Presentation from Canadian Coalition for Nuclear Responsibility & Prolet Inc.

Application for a licence to construct one BWRX-300 reactor at the Darlington New Nuclear Project Site (DNNP)

BWRX-300 – a “Small Modular Nuclear Reactor” that is Not Small, Not Modular, and Not Yet Fully Designed

The GE-Hitachi BWRX-300 is
a 300 Megawatt Electricity-Producing
Boiling Water Reactor (BWR Version 10)

Simplicity drives cost reduction

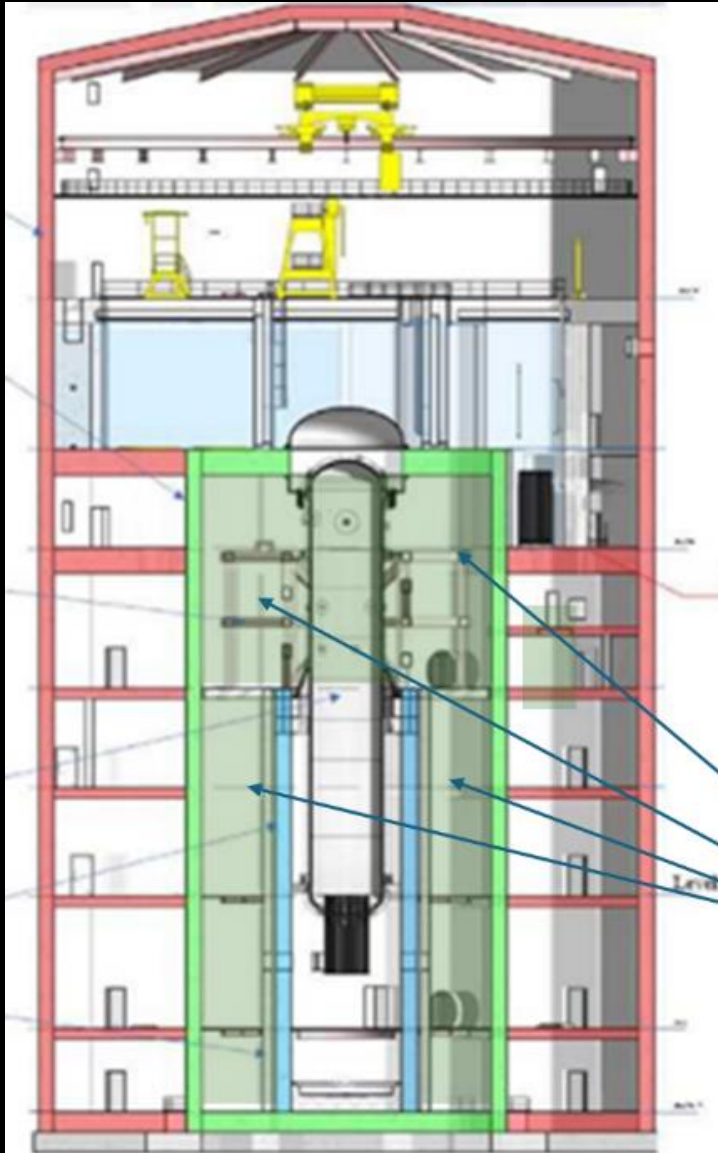
Reduction in size is due in part to elimination of safety systems.

Reduction in size means too small containment.

Can't be much larger unless the diameter of reactor building is increased.

Containment is this color
